N32N LA-733 REV. 4A SCHEMATIC DOCUMENT uPGA2 COPPERMINE with Geyserville

Title
SCHEMATIC, M/B LA-733

Size B	Document Number 401138	Rev 4C
------------------	---------------------------	-----------

HOST INTERFACE

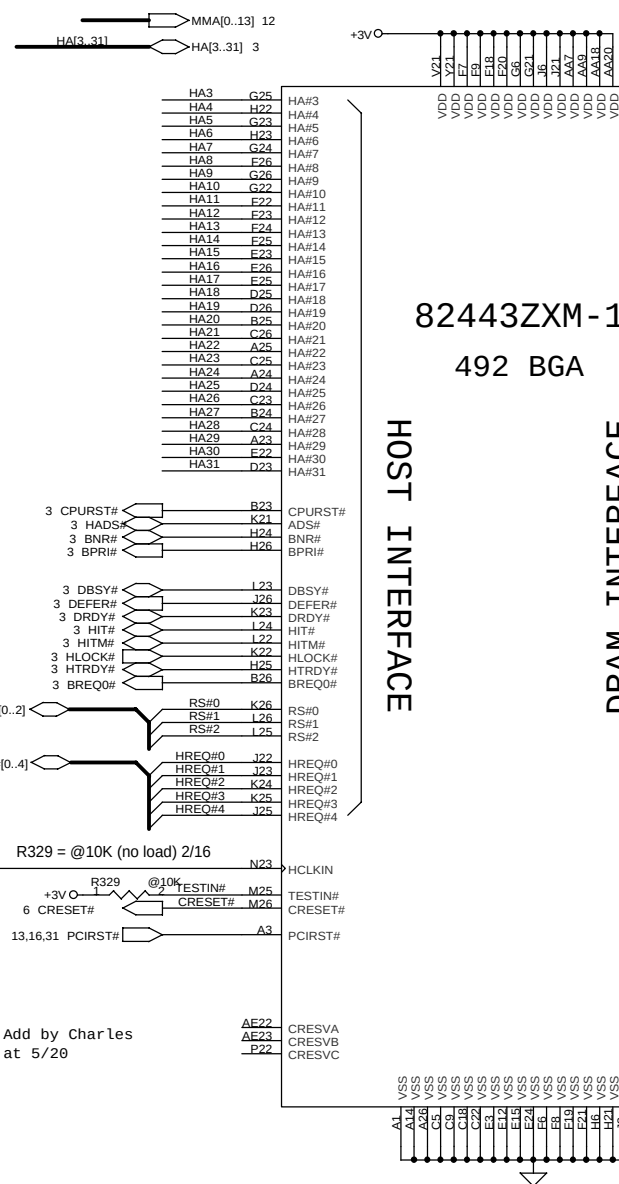
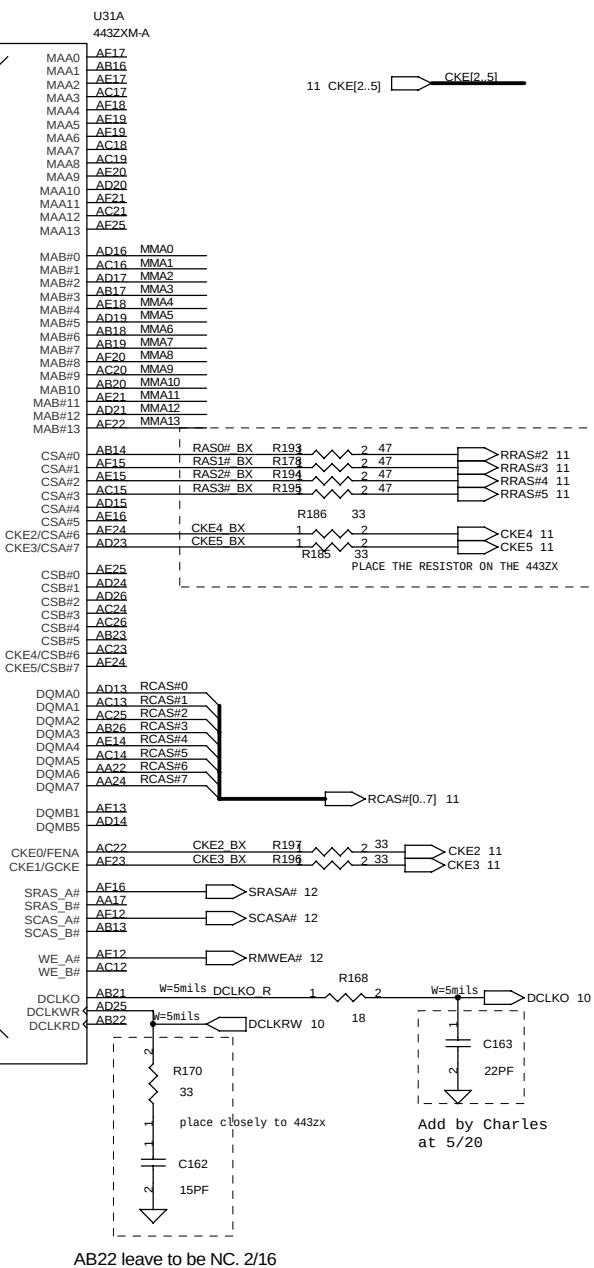
AB22 leave to be NC. 2/16

Add by Charles
at 5/20

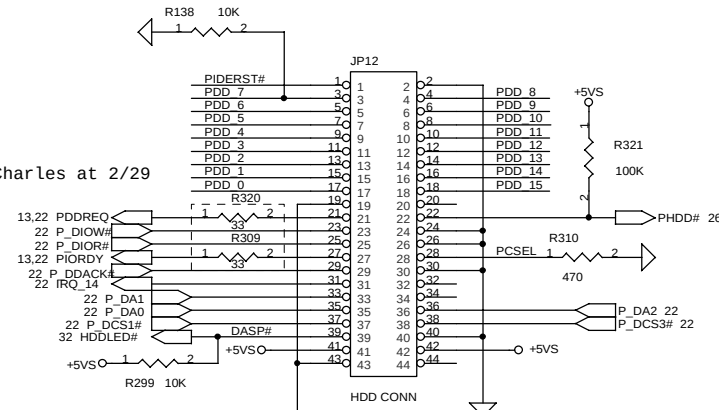
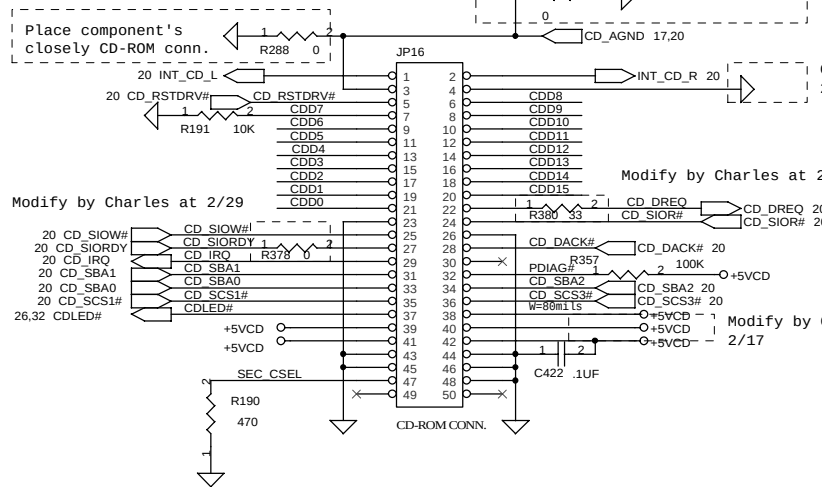
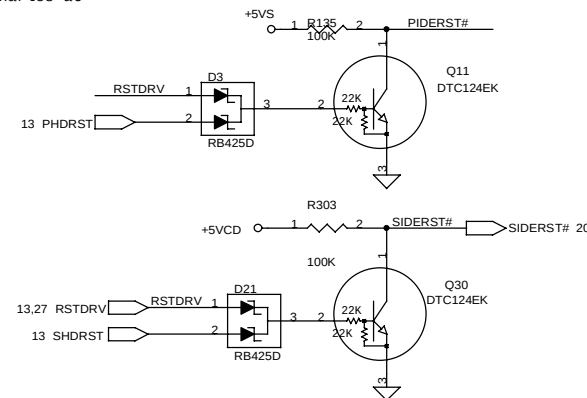
Modify by Charles at 2/29

Add by Charles at 2/16

+5VCD
R189 10K
Add by Charles at 2/16

Modify by Charles at 2/29

Modify by Charles at 2/29

Modify by Charles at 2/17
